# Critique of Pebble Limited Partnership's Seismic Hazard Assessment

Dr. Bretwood Higman, Ground Truth Trekking

Figure 1: PLP (2012 Ch 6) concludes that the Lake Clark Fault is inactive, and veers away from the mine site. This conclusion is not supported by either PLP's work, or existing literature - the fault's location near Pebble, and its activity, are unknown.

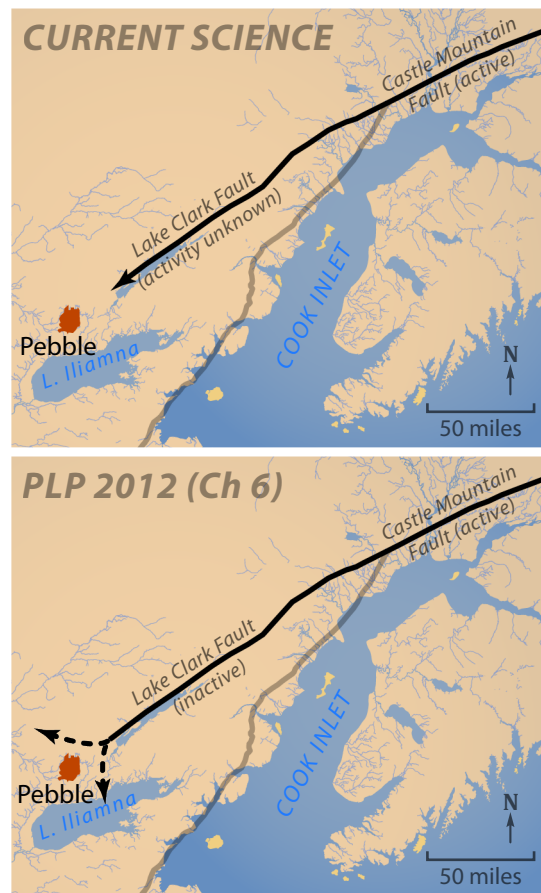
The Lake Clark Fault is a major fault connected to the well-known Castle Mountain fault in south-central Alaska. It trends northeast to southwest, from near Beluga, through the Tlikakila River valley, and then along Lake Clark (Nelson et al., 1983). The fault has not been mapped further southwest than this. Taking the simplest assumption, that the fault continues on its mapped course, it would pass through or near the Pebble prospect (Figure 1).

This is inaccurate. Haeussler & Saltus (2004) stopped mapping the fault where their survey data ended. They did not suggest that the fault ended at this point. PLP (2012 Ch6) acknowledges the fault may continue, but implications are not discussed. Haeussler & Saltus (2004) show the Lake Clark Fault has moved 16 miles at Lake Clark. This motion on the fault (offset) cannot simply end – the fault must either extend further, or transition into some other fault.

Glaciers frequently cross faults, including the Lake Clark Fault further to the northeast. Many active faults are not parallel with landscape features (such as ridges and valleys) that typically control glacial flow (e.g. the Seattle Fault, Sherrod et al. 2008). For the Lake Clark Fault to track with glacial advance, it would have to make an abrupt, unusual turn (Figure 1). PLP presents no evidence that the fault actually makes this turn.

Figure 2 (PLP 2012 3.7.3, figure 3-6a): PLP maps the bedrock near Pebble Prospect. Blue lines are small faults in the area. The deposit is outlined in yellow near the northeast corner of the map.

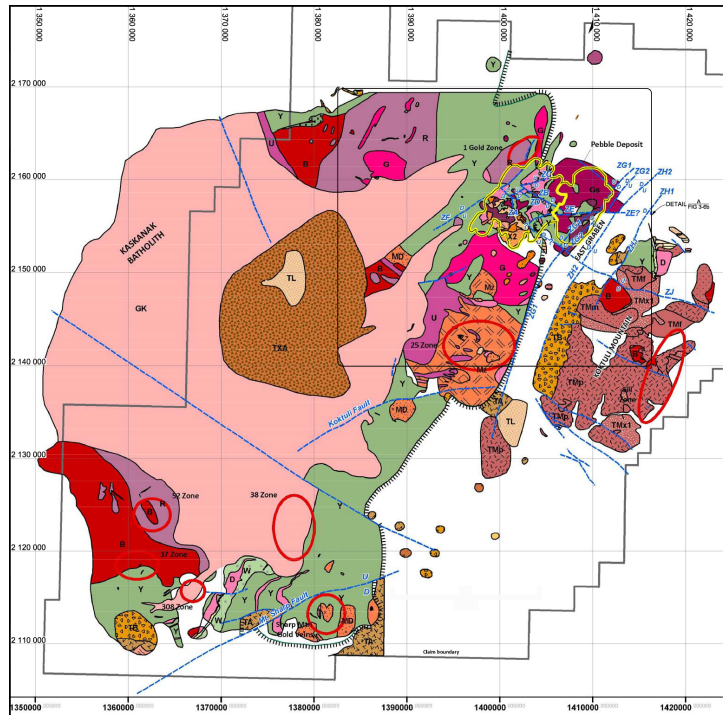
Near the Pebble prospect, PLP (2012 3.7.3) mapped a number of faults, demonstrating that the rock is susceptible to faulting. Detailed information on these faults can be found in the EBD, chapter 3. They are depicted in figure 3-6a.

PLP's (2012 3.7.3) geologic map (Fig. 2) shows a number of small faults cutting bedrock in the vicinity of the mine. These faults are not discussed in the PLP (2012 Ch 6) seismic hazard assessment.

PLP (2012 3.7.3) maps several parallel small faults that have allowed a wedge of bedrock to shift downward, a "graben," within the mine area. In their 2006 mine plan (DNR, 2006), a tailings dam is planned directly over this graben. This is a scenario where a fault might be activated by a human activity. Grabens form where the earth stretches, and large blocks of bedrock sink downwards along faults. Since the weight of a tailings facility would apply increased downward pressure to this graben, it has an increased chance of triggering an earthquake (McGarr et al. 2002).
